Alliance of Automobile Manufacturers

Head Restraint GTR Input

6-13-05

FMVSS 202a: A starting point

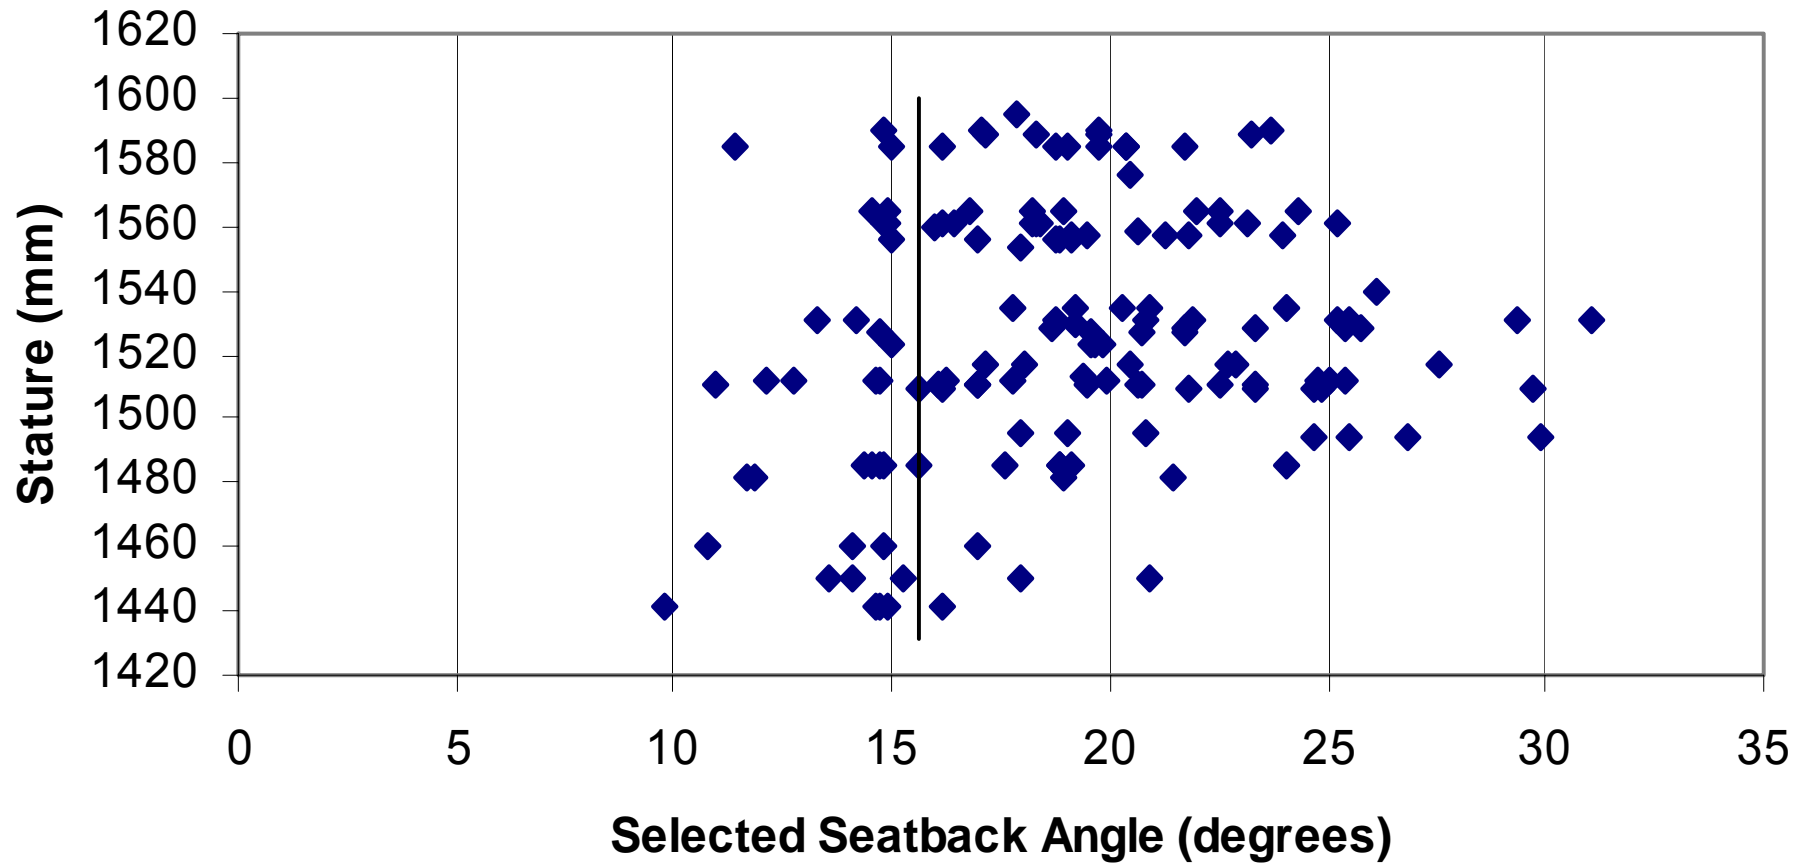
- Field data indicates that seats designed to meet 50mm backset are irritating to short stature adults
- HRMD does not correlate to human experience
- 25° is not the average of human seating positions
- 3mm/degree backset change is not representative of all vehicles
- More study of HRMD needed for tolerance and accuracy
- Compare J826 HRMD with Aspect HRMD

Issue Raised in Alliance Petition

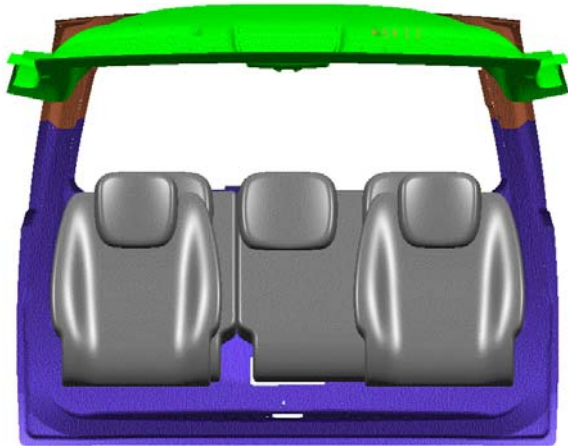
Outboard Rear Seat Non-Use Positions:

- Allow outboard rear head restraints that stow into a full-down position of $<700\text{mm}$, yet allow for an occupant-adjusted position of $>700\text{mm}$.

These head restraints are to be capable of achieving 750mm in an adjusted position and meet retention and energy absorption requirements specified in the standard.

Preferred Gap Measurement Procedure

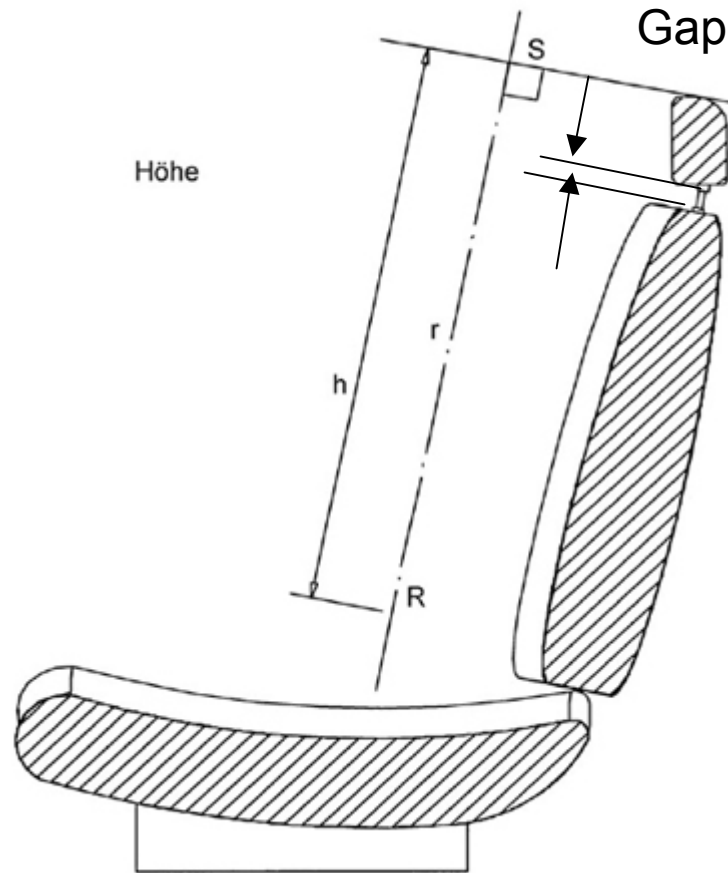
- 60 mm gap using 165 mm sphere between seat and head restraint exaggerates gaps and overlaps.
- Use ECE R17 measurement method.

“Effective” Height Measurement Method – Fixed Height

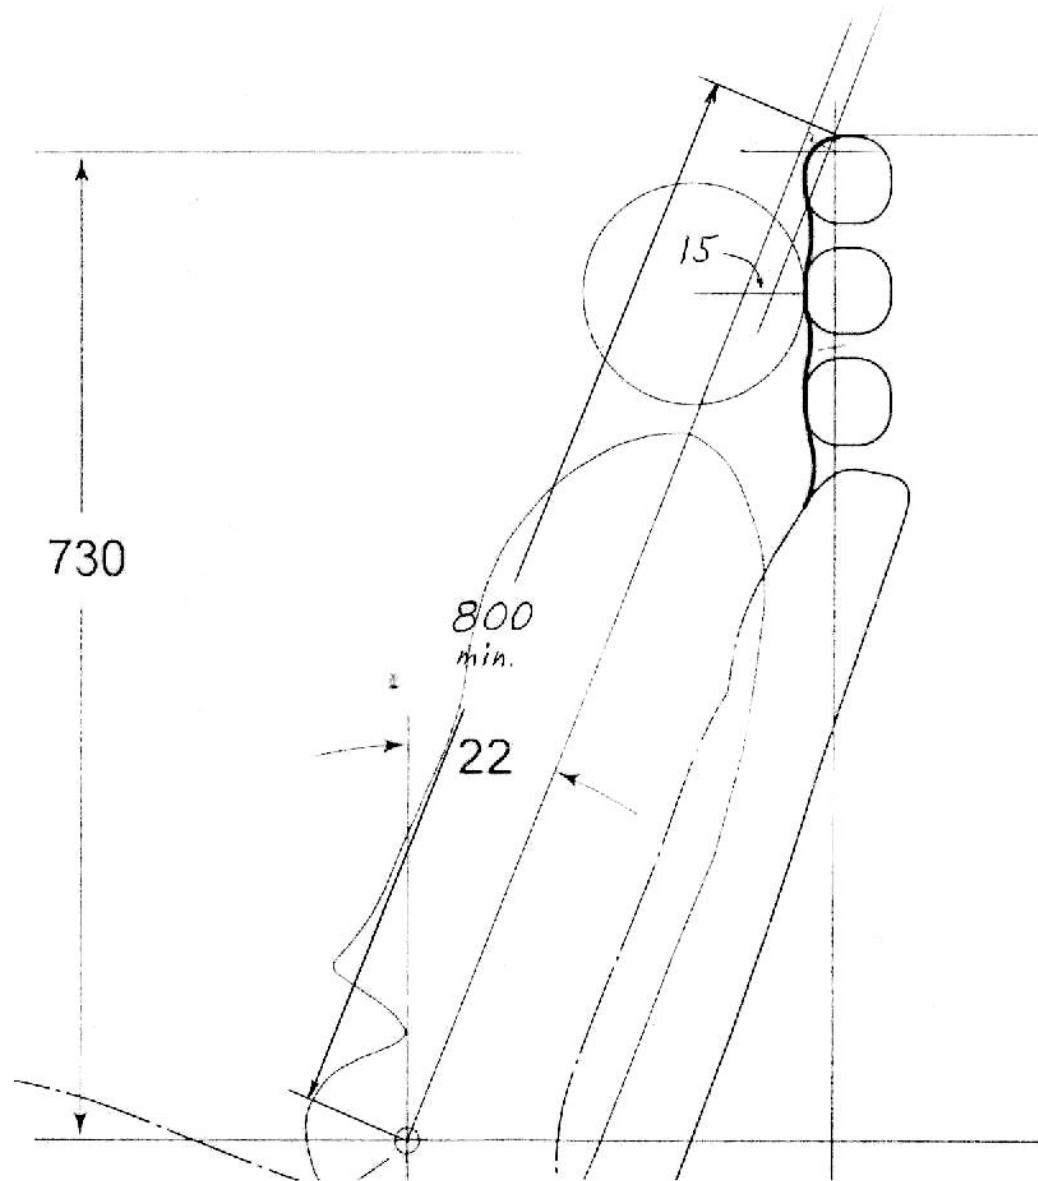
5.5.2.1 For static front outboard head restraints not adjustable for height, the height shall be not less than 800 mm when measured from the R-point (design H-point) along the design torso reference line to a line perpendicular to the torso reference line intersecting the head restraint at a point 15 mm (measured horizontally) behind the torso reference line. If the head restraint is adjustable fore-aft, the height is to be measured in the foremost adjusted position.
